Figure1 – Pressure air release vent required at Kiwi Esplanade

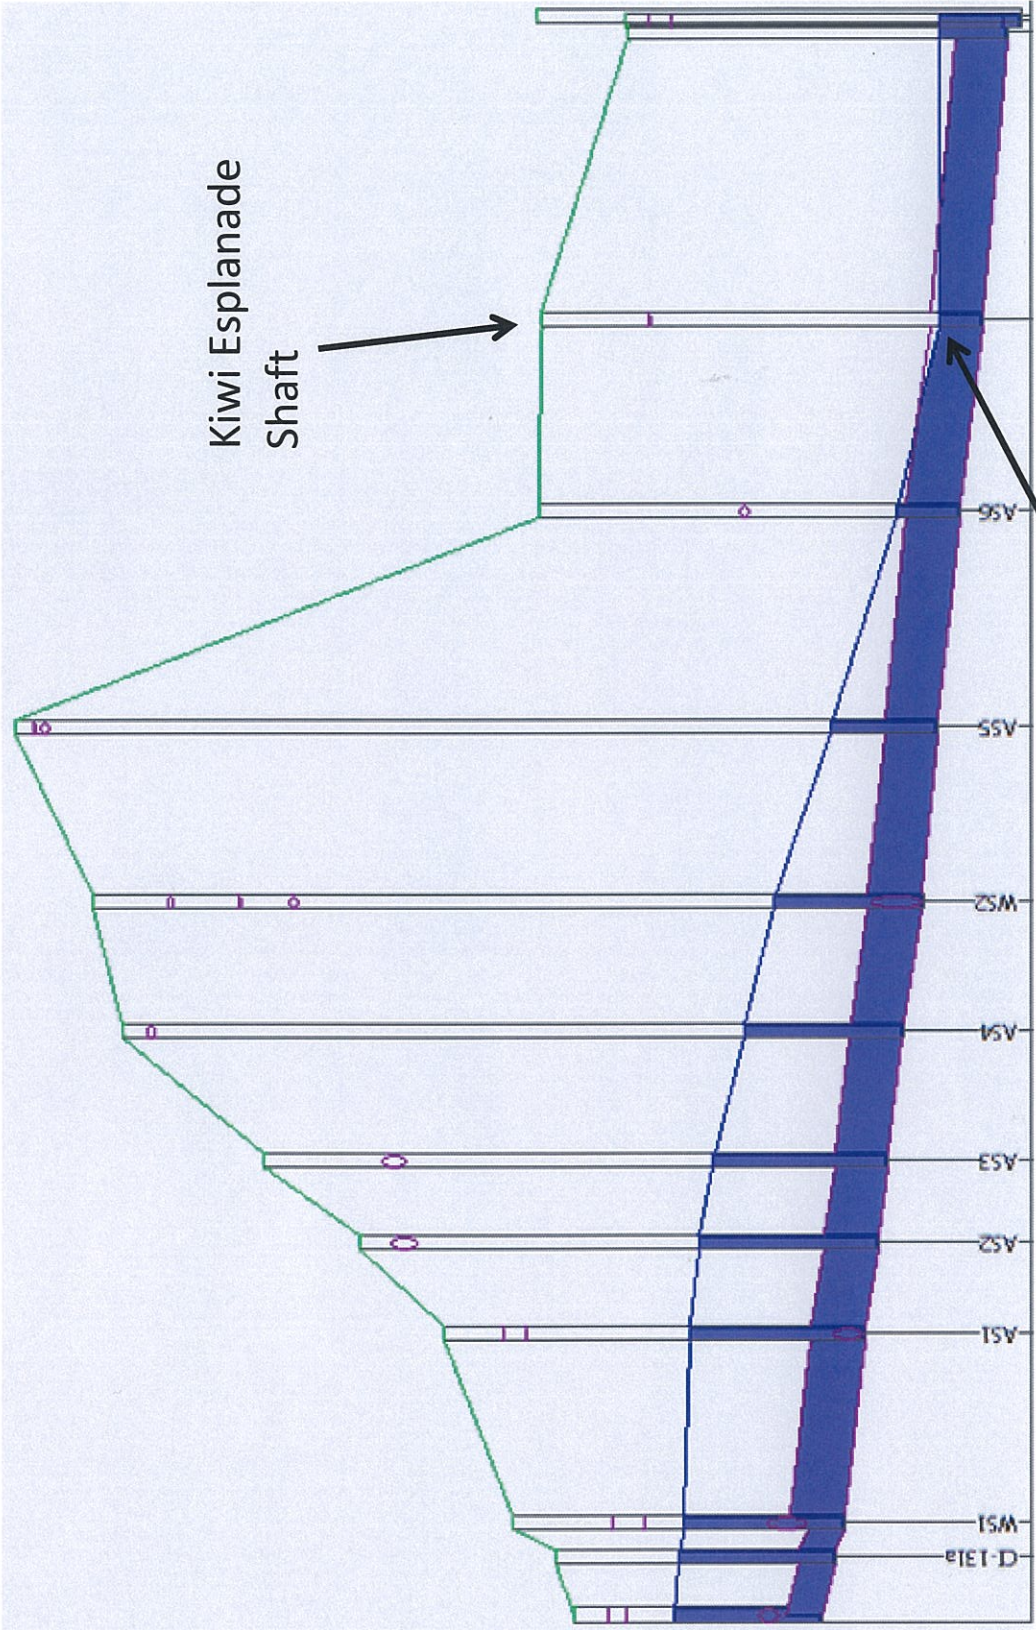
Air pocket which needs to be vented
